- REVIEWED  
□ REVIEWED AS NOTED  
□ REVISE AND RESUBMIT

ROUNDEL HOMES INC. (PH-2)

LOT No. 63

CURRENT DRIVE

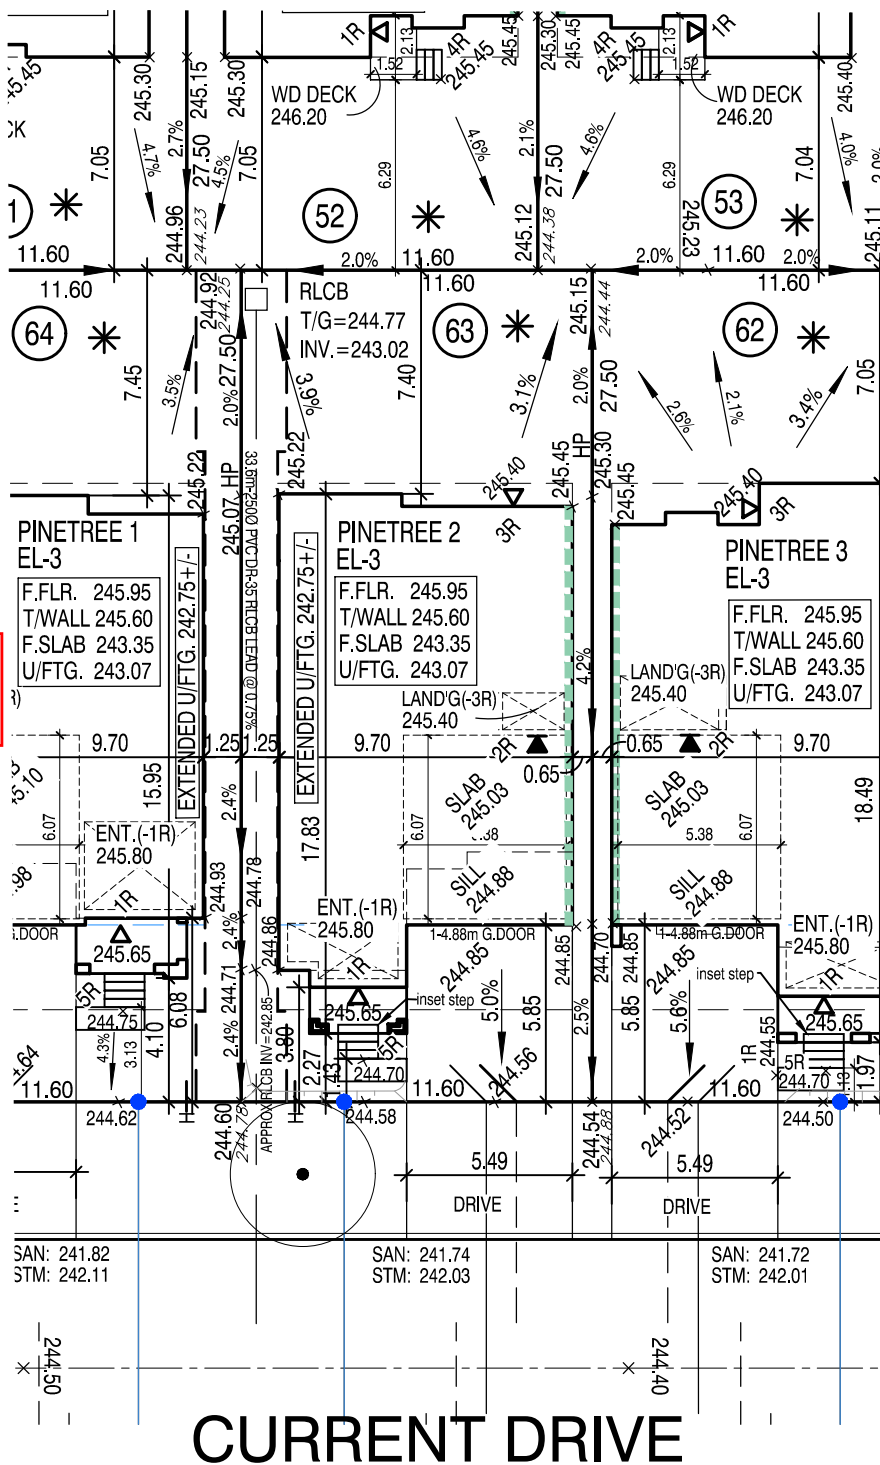
No unprotected openings permitted within 1.2 metres of the lot line as per 9.10.14 of the Ontario Building Code.

45 MINUTE RATED WALL  
WITH SIDE YARD < 1.2m
